MCPB
Item No. 10/11
11-01-2001

PROJECTS: US 29 From South of Blackburn Road to North of Dustin Road
Mandatory Referral No. 01809-SHA-1

US 29 at East Randolph Road/Cherry Hill Road
Mandatory Referral No. 01810-SHA-1

REVIEW TYPE: Mandatory Referral

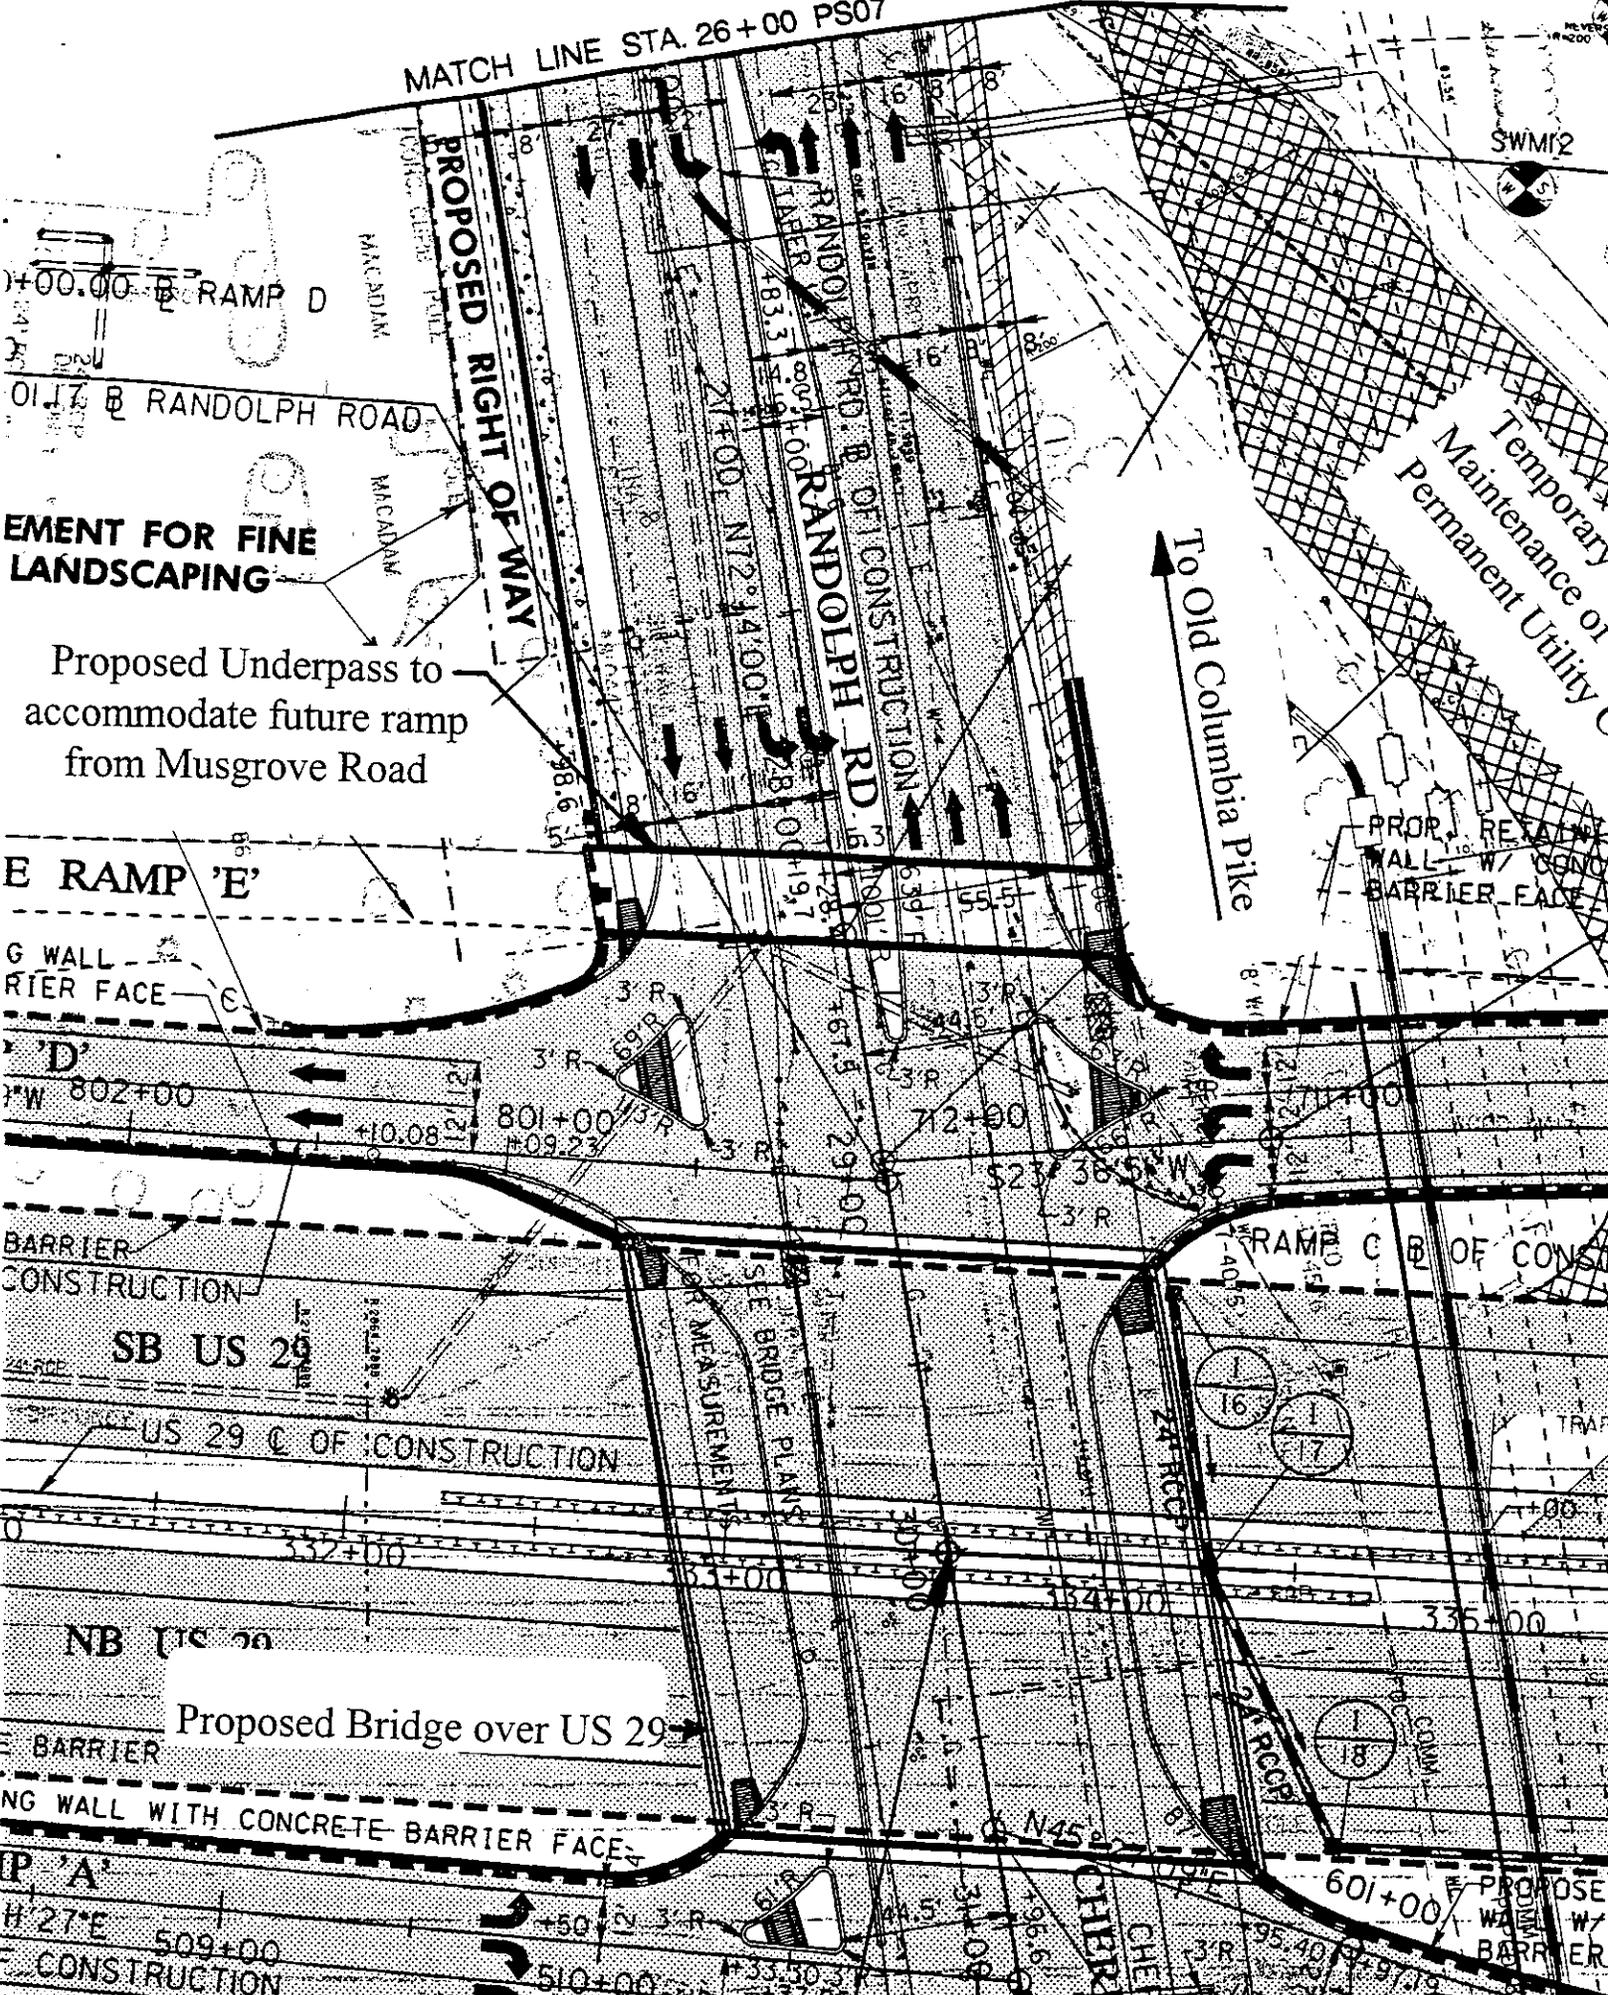
Staff recommends moving the sidewalk behind the handicap ramp where possible

Proposed right-turn lane will be added by SHA

Staff recom
sidewalk or
th

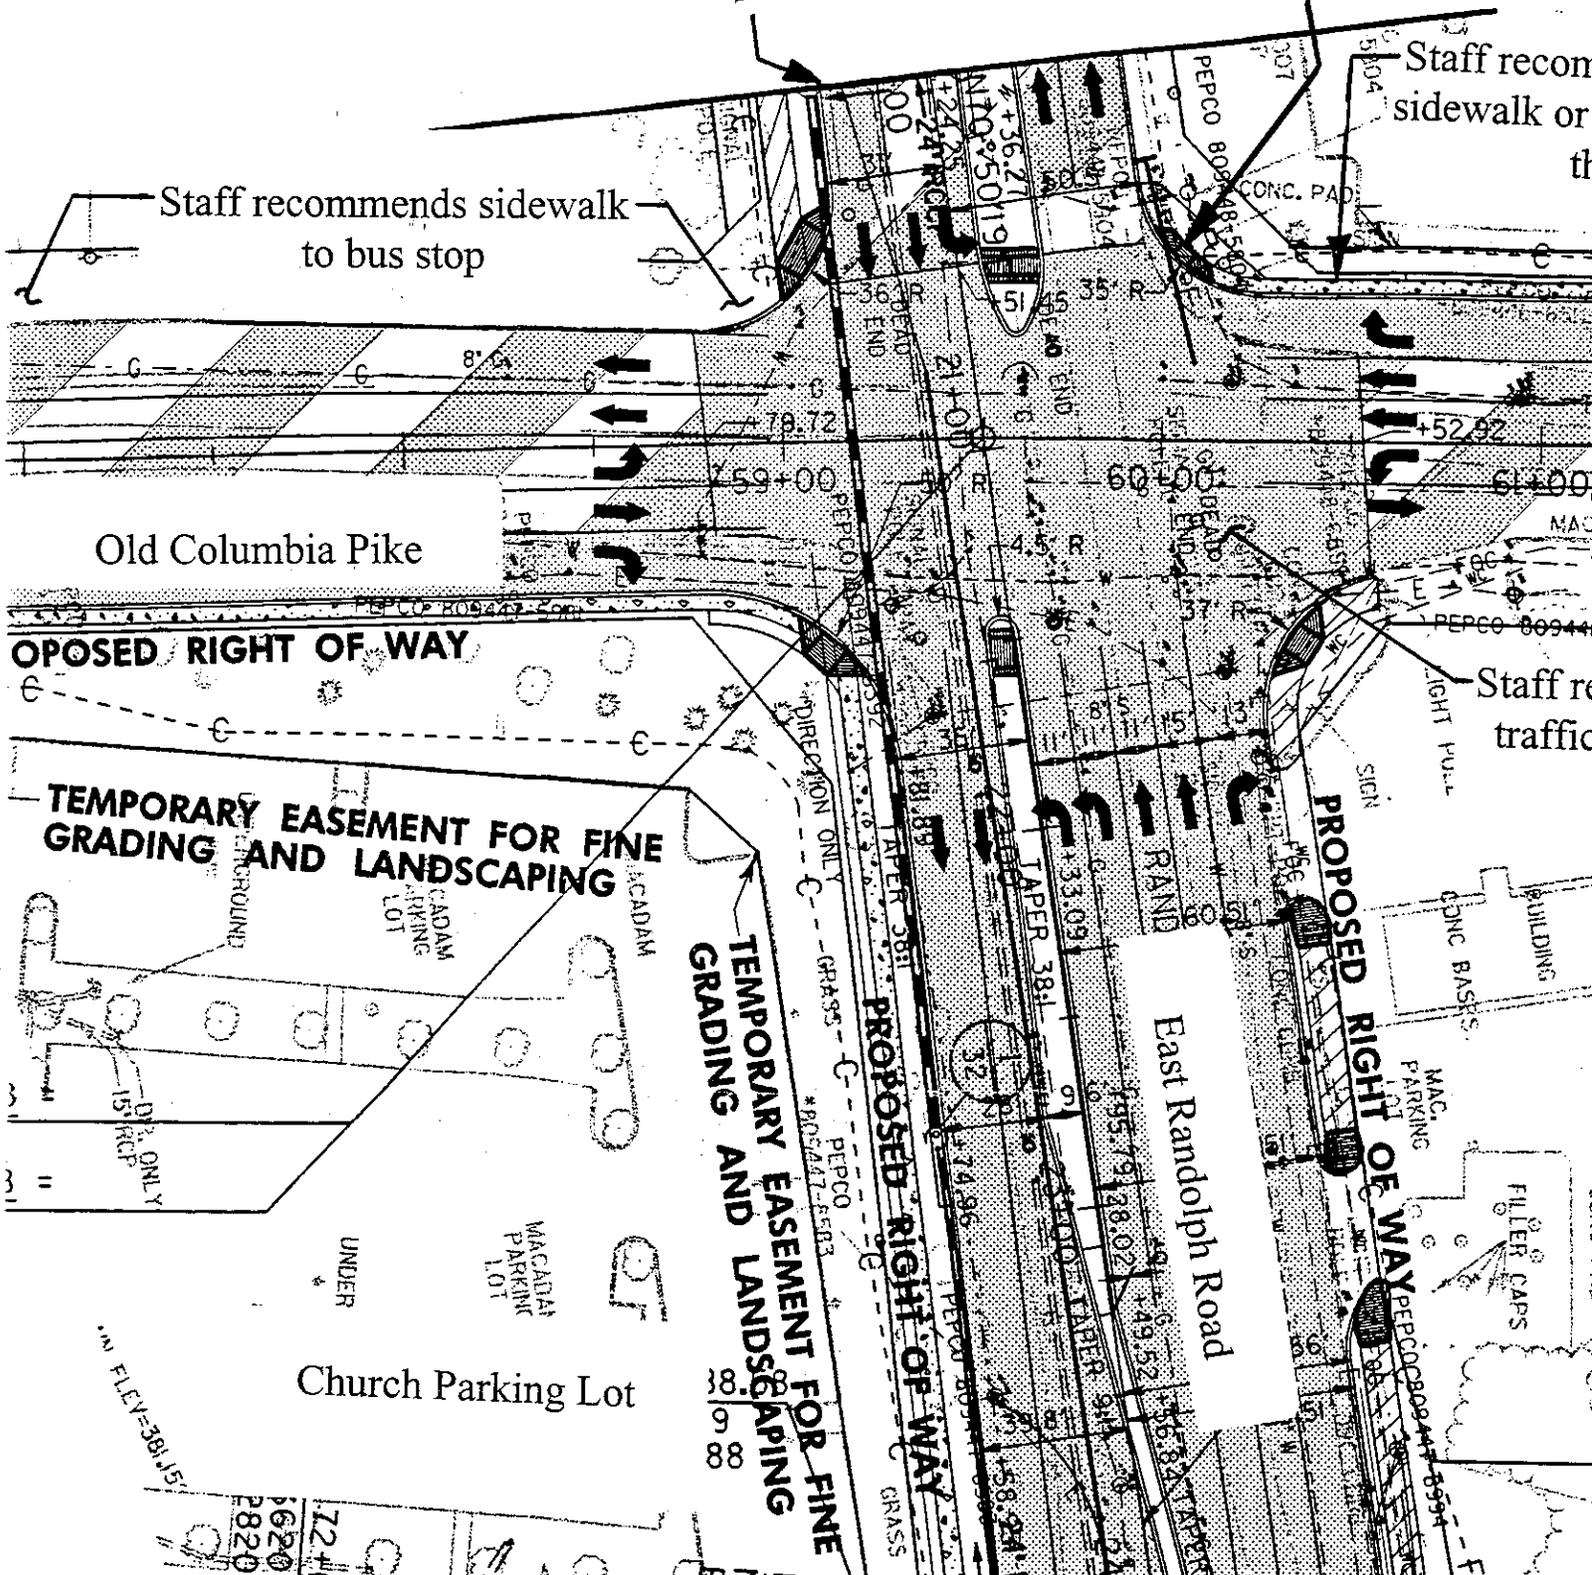
Staff recommends sidewalk to bus stop

Staff re
traffic

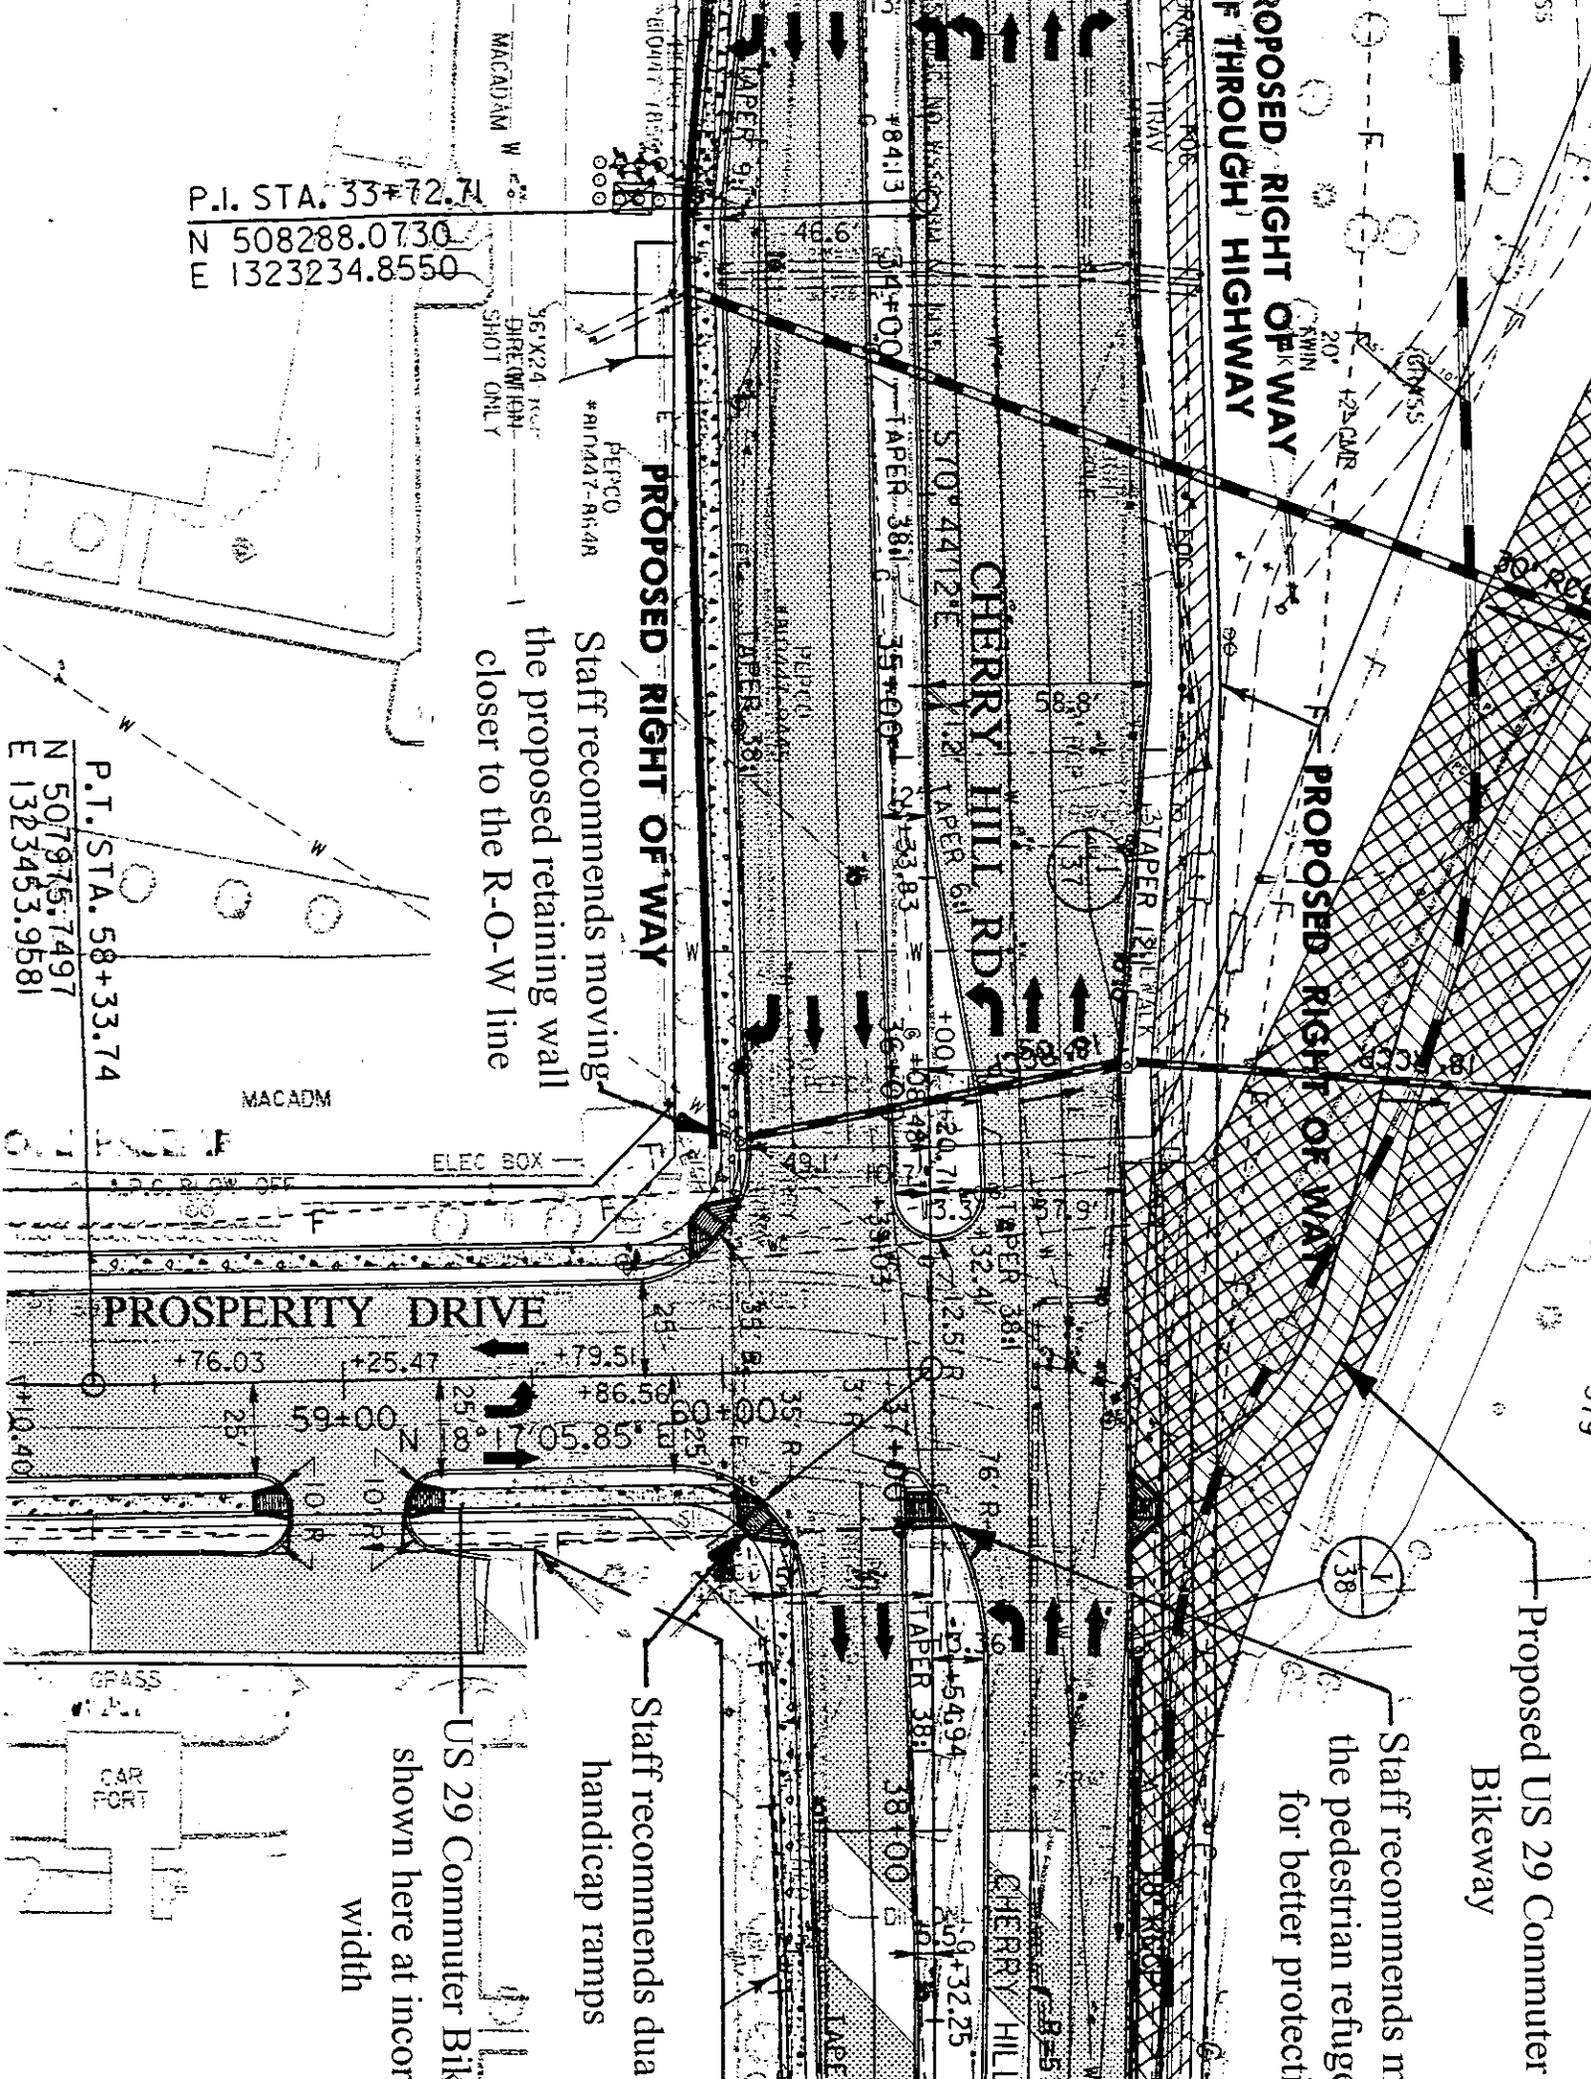
Staff recommends n
the pedestrian refuge
for better protect

Staff recommends moving
the proposed retaining wall
closer to the R-O-W line

Staff recommends dua
handicap ramps
US 29 Commuter Bik
shown here at incor
width
